June 13, 2023

"That this matter be referred to staff to work with the applicant to achieve greater consistency in relation to setbacks, building height, and privacy of the new buildings."

A letter to Mayor and Council June 5, 2021 describes the many details of this project with respect to heritage designation, green building, project benefits, government policy, community and city engagement as well as landscape and building design. The purpose of this letter is to provide a review of the proposal and describe the changes made in response to Council's motion of October 28, 2021.

Building A Modifications

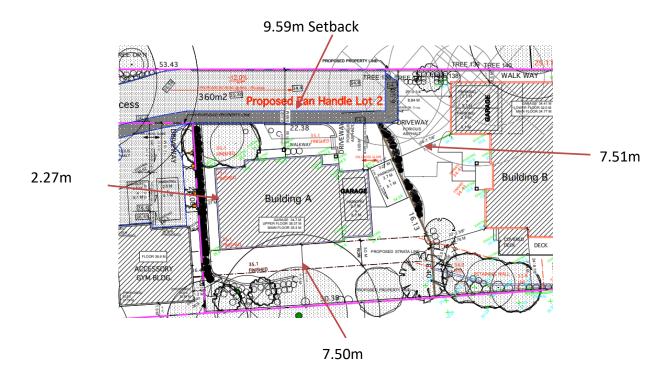
All upper bedroom windows had been removed from the rear (south), to eliminate any possible overlooks to the neighbour on Lymann Duff. The only window on this elevation is an obscured bathroom window.

To help reduce visual impact the building height was reduced from 6.87m to 6.6m by changing the top floor ceiling height to 8'.

The panhandle zone calls for a single storey building, again in support of privacy. However, the size of the lot allows a second storey because there are sufficient setbacks (see below) to avoid privacy concerns. Note the second floor is stepped in significantly and is about half the size of the main floor, making this a $1\frac{1}{2}$ storey building.

Looking Up to Neighbour

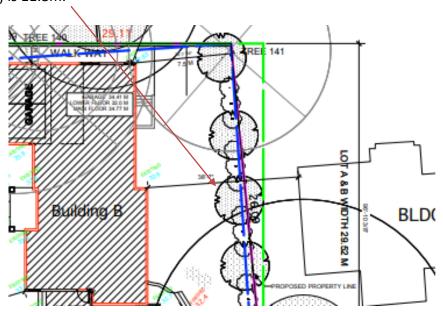
To further illustrate privacy protection, the distance from the proposed house to the neighbours closest window is almost 20m.

There is also a large tree in the neighbour's yard obscuring any visual impact. As well, the neighbour's deck is higher which actually looks over/down onto proposed building A suggesting there will be very little, if any, privacy impact for this neighbour.

East Neighbour

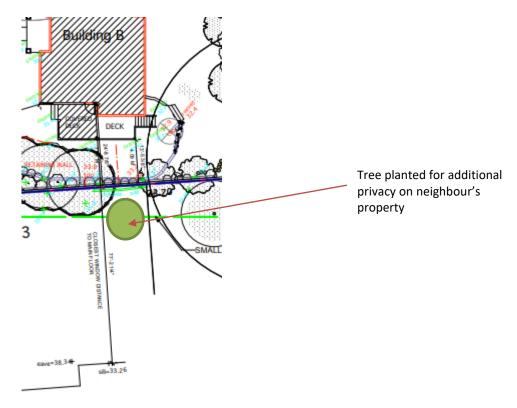
Building B was pulled to the west (moved 'forward') which increased the east (rear) setback from 5.0m to 7.5m, to align with policy. The actual distance between the buildings (to the east neighbour) is 11.8m.

Notably, the east elevation faces the side yard of our neighbour, and more specifically is adjacent a side where there are very few windows. In addition to the increased setback the neighbour's rear yard and recreation area is further obscured by a large tree on their property.
